PRODUCT/PROCESS CHANGE NOTICE (PCN)

PCN #: **TB1503-01** DATE: **July 22, 2015**
Product Affected: **TSSOP-20, TSSOP-24, TSSOP-28,
TSSOP-48, TSSOP-56, TVSOP-48
SOIC-28, SSOP-20, SSOP-28,**
(Refer to Attachment II for affected part# shipped in Reel)
Date Effective: **November 2, 2015 Earliest Date - Refer to
specific date by package type**

This notification is to advise our customers that IDT has planned to standardize the carrier tape used to one type on selective package types.

Illustration of Carrier Tape Pocket Design Change

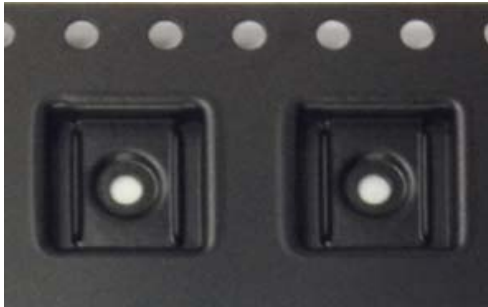
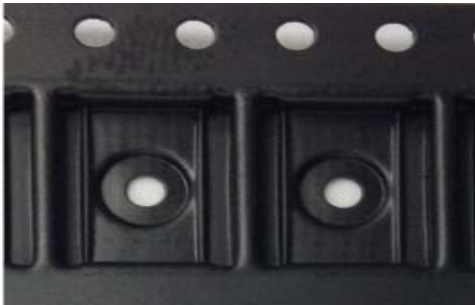
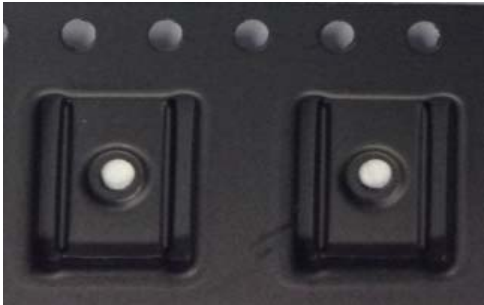
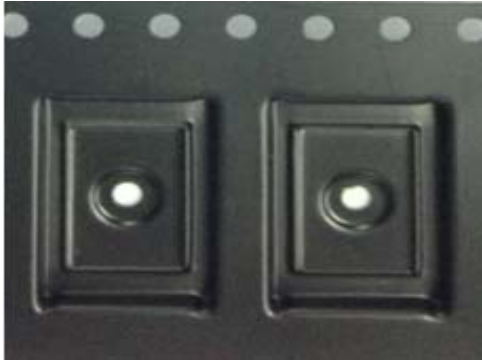
Description	From	To
IDT Carrier Tape Part#	P8-464-000	P8-291-P20
IDT Carrier Tape Drawing#	MSC-7521	MSC-7519
Supplier Carrier Tape Part#	PGG20-20B3-360C-SD	eCA1760-PS-BLK-350
Supplier	PCT	E-PAK
Pocket Width, Ao (mm)	7.15 $\pm$ 0.05	7.00 $\pm$ 0.10
Pocket Length, Bo (mm)	6.90 $\pm$ 0.05	7.00 $\pm$ 0.10
Pocket Depth, Ki (mm)	1.25 $\pm$ 0.05	1.30 $\pm$ 0.10
Pocket Pitch, P1 (mm)	12.0 $\pm$ 0.1	8.0 $\pm$ 0.1
Total Pocket Depth, Ko (mm)	1.55 $\pm$ 0.05	1.60 $\pm$ 0.10
Carrier Tape Width, W (mm)	16.0 +0.2/-0.1	16.0 +0.2/-0.1
Carrier Tape Thickness, T (mm)	0.30 $\pm$ 0.05	0.30 $\pm$ 0.05

Description	From	To
IDT Carrier Tape Part#	P8-329-P24	P8-169-P24
IDT Carrier Tape Drawing#	MSC-5914	MSC-3388
Supplier Carrier Tape Part#	TSSOP24L-20B3-360C-SD	TSS30P12GP-20B3-360-SD
Supplier	PCT	PCT
Pocket Width, Ao (mm)	6.85 $\pm$ 0.10	7.00 $\pm$ 0.10
Pocket Length, Bo (mm)	8.20 $\pm$ 0.10	8.20 $\pm$ 0.10
Pocket Depth, Ki (mm)	1.40 $\pm$ 0.10	1.30 $\pm$ 0.10
Pocket Pitch, P1 (mm)	8.00 $\pm$ 0.10	12.00 $\pm$ 0.10
Total Pocket Depth, Ko (mm)	1.70 $\pm$ 0.10	1.55 $\pm$ 0.10
Carrier Tape Width, W (mm)	16.0 +0.2/-0.1	16.0 +0.2/-0.1
Carrier Tape Thickness, T (mm)	0.30 $\pm$ 0.05	0.30 $\pm$ 0.05

Description	From	To
IDT Carrier Tape Part#	P8-260-P48	P8-324-P48
IDT Carrier Tape Drawing#	MSC-7388	MSC-7539
Supplier Carrier Tape Part#	TSS48P16GP-22B3-360C-SD	eCA1765-PS-BLK-350
Supplier	PCT	E-PAK
Pocket Width, Ao (mm)	8.45 $\pm$ 0.13	8.85 $\pm$ 0.10
Pocket Length, Bo (mm)	13.00 $\pm$ 0.13	12.90 $\pm$ 0.10
Pocket Depth, Ki (mm)	1.20 $\pm$ 0.10	1.30 $\pm$ 0.10
Pocket Pitch, P1 (mm)	16.00 $\pm$ 0.10	12.00 $\pm$ 0.10
Total Pocket Depth, Ko (mm)	1.60 $\pm$ 0.10	1.50 $\pm$ 0.10
Carrier Tape Width, W (mm)	24.0 +0.2/-0.1	24.0 +0.2/-0.1
Carrier Tape Thickness, T (mm)	0.30 $\pm$ 0.05	0.30 $\pm$ 0.05

Package	From	To
TSSOP-20	Carrier Tape Part# P8-464-000 	Carrier Tape Part# P8-291-P20 
TSSOP-24	Carrier Tape Part# P8-329-P24 	Carrier Tape Part# P8-169-P24 
TSSOP-48	Carrier Tape Part# P8-260-P48 	Carrier Tape Part# P8-324-P48

Illustration of Carrier Tape Pocket Design Change

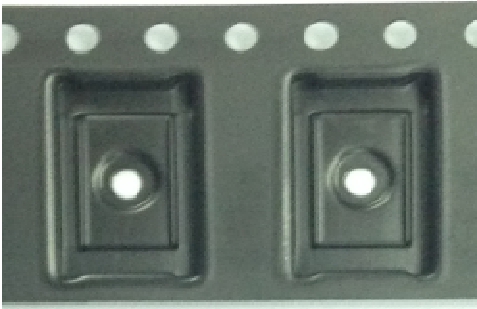
Description	From	To
IDT Carrier Tape Part#	P8-187-S28	P8-370-P28
IDT Carrier Tape Drawing#	MSC-3405	MSC-5938
Supplier Carrier Tape Part#	SO28NP-22B3-75C-SD	SO28W32-22B3-62C-SD
Supplier	PCT	PCT
Pocket Width, Ao (mm)	10.80 $\pm$ 0.10	10.90 $\pm$ 0.10
Pocket Length, Bo (mm)	18.55 $\pm$ 0.10	18.55 $\pm$ 0.10
Pocket Depth, Ki (mm)	2.60 $\pm$ 0.10	2.70 $\pm$ 0.10
Pocket Pitch, P1 (mm)	12.00 $\pm$ 0.10	16.00 $\pm$ 0.10
Total Pocket Depth, Ko (mm)	3.00 $\pm$ 0.10	3.10 $\pm$ 0.10
Carrier Tape Width, W (mm)	24.0 $\pm$ 0.3	32.0 $\pm$ 0.3
Carrier Tape Thickness, T (mm)	0.30 $\pm$ 0.05	0.30 $\pm$ 0.05

Description	From	To
IDT Carrier Tape Part#	P8-145-PF8	P8-330-P48
IDT Carrier Tape Drawing#	MSC-3196	MSC-5915
Supplier Carrier Tape Part#	TSS28/38GP-22B3-120-SD	TSSOP48LGP-22B7-120C-SD
Supplier	PCT	PCT
Pocket Width, Ao (mm)	6.90 $\pm$ 0.13	7.10 $\pm$ 0.10
Pocket Length, Bo (mm)	10.10 $\pm$ 0.13	10.10 $\pm$ 0.10
Pocket Depth, Ki (mm)	1.30 $\pm$ 0.10	1.30 $\pm$ 0.10
Pocket Pitch, P1 (mm)	12.00 $\pm$ 0.10	12.00 $\pm$ 0.10
Total Pocket Depth, Ko (mm)	1.50 $\pm$ 0.10	1.50 $\pm$ 0.10
Carrier Tape Width, W (mm)	16.00 $\pm$ 0.30	24.0 +0.2/-0.1
Carrier Tape Thickness, T (mm)	0.30 $\pm$ 0.05	0.30 $\pm$ 0.05

Description	From	To
IDT Carrier Tape Part#	P8-261-P56	P8-314-P56
IDT Carrier Tape Drawing#	MSC-7398	MSC-7543
Supplier Carrier Tape Part#	PA56SGP-22B3-360C-SD	eCA1764-PS-BLK-350
Supplier	PCT	E-PAK
Pocket Width, Ao (mm)	8.45 $\pm$ 0.13	8.85 $\pm$ 0.10
Pocket Length, Bo (mm)	14.50 $\pm$ 0.13	14.60 $\pm$ 0.10
Pocket Depth, Ki (mm)	1.20 $\pm$ 0.13	1.30 $\pm$ 0.10
Pocket Pitch, P1 (mm)	16.00 $\pm$ 0.10	12.00 $\pm$ 0.10
Total Pocket Depth, Ko (mm)	1.60 $\pm$ 0.13	1.50 $\pm$ 0.10
Carrier Tape Width, W (mm)	24.0 $\pm$ 0.3	24.0 +0.2/-0.1
Carrier Tape Thickness, T (mm)	0.30 $\pm$ 0.05	0.30 $\pm$ 0.05

Package	From	To
SOIC-28	Carrier Tape Part# P8-187-S28 	Carrier Tape Part# P8-370-P28 
TSSOP-28 and TVSOP-48	Carrier Tape Part# P8-145-PF8 	Carrier Tape Part# P8-330-P48 
TSSOP-56	Carrier Tape Part# P8-261-P56 	Carrier Tape Part# P8-314-P56

Illustration of Carrier Tape Pocket Design Change

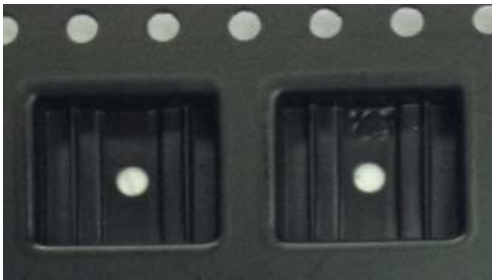
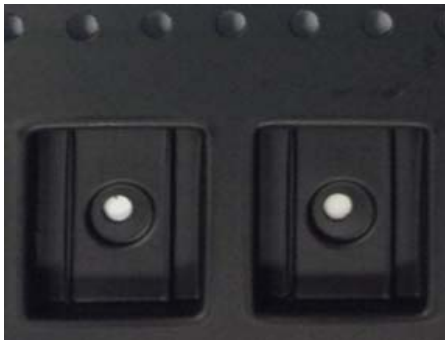
Description	From	To
IDT Carrier Tape Part#	P8-259-P20	P8-320-P20
IDT Carrier Tape Drawing#	MSC-7395	MSC-5909
Supplier Carrier Tape Part#	SSOP20SGP-22B3-360C-SD	SSOP20GP-22B3-80C-SD
Supplier	PCT	PCT
Pocket Width, Ao (mm)	8.20 $\pm$ 0.10	8.60 $\pm$ 0.10
Pocket Length, Bo (mm)	7.50 $\pm$ 0.10	7.60 $\pm$ 0.10
Pocket Depth, Ki (mm)	2.10 $\pm$ 0.10	2.00 $\pm$ 0.10
Pocket Pitch, P1 (mm)	12.00 $\pm$ 0.10	12.00 $\pm$ 0.10
Total Pocket Depth, Ko (mm)	2.50 $\pm$ 0.10	2.30 $\pm$ 0.10
Carrier Tape Width, W (mm)	16.0 $\pm$ 0.3	16.0 $\pm$ 0.3
Carrier Tape Thickness, T (mm)	0.30 $\pm$ 0.05	0.30 $\pm$ 0.05

Description	From	To
IDT Carrier Tape Part#	P8-384-P28	P8-321-P28
IDT Carrier Tape Drawing#	MSC-7356	MSC-5910
Supplier Carrier Tape Part#	EIAJ14GP-22B3-75C-SD	SSOP28W24PGP-22B3-180C-SD
Supplier	PCT	PCT
Pocket Width, Ao (mm)	8.40 $\pm$ 0.10	8.90 $\pm$ 0.10
Pocket Length, Bo (mm)	10.70 $\pm$ 0.10	10.60 $\pm$ 0.10
Pocket Depth, Ki (mm)	2.10 $\pm$ 0.10	2.00 $\pm$ 0.10
Pocket Pitch, P1 (mm)	12.00 $\pm$ 0.10	12.00 $\pm$ 0.10
Total Pocket Depth, Ko (mm)	2.40 $\pm$ 0.10	2.30 $\pm$ 0.10
Carrier Tape Width, W (mm)	16.0 $\pm$ 0.3	24.0 $\pm$ 0.3
Carrier Tape Thickness, T (mm)	0.30 $\pm$ 0.05	0.30 $\pm$ 0.05

Package	From	To
SSOP-20	Carrier Tape Part# P8-259-P20 	Carrier Tape Part# P8-320-P20 
SSOP-28	Carrier Tape Part# P8-384-P28 	Carrier Tape Part# P8-321-P28
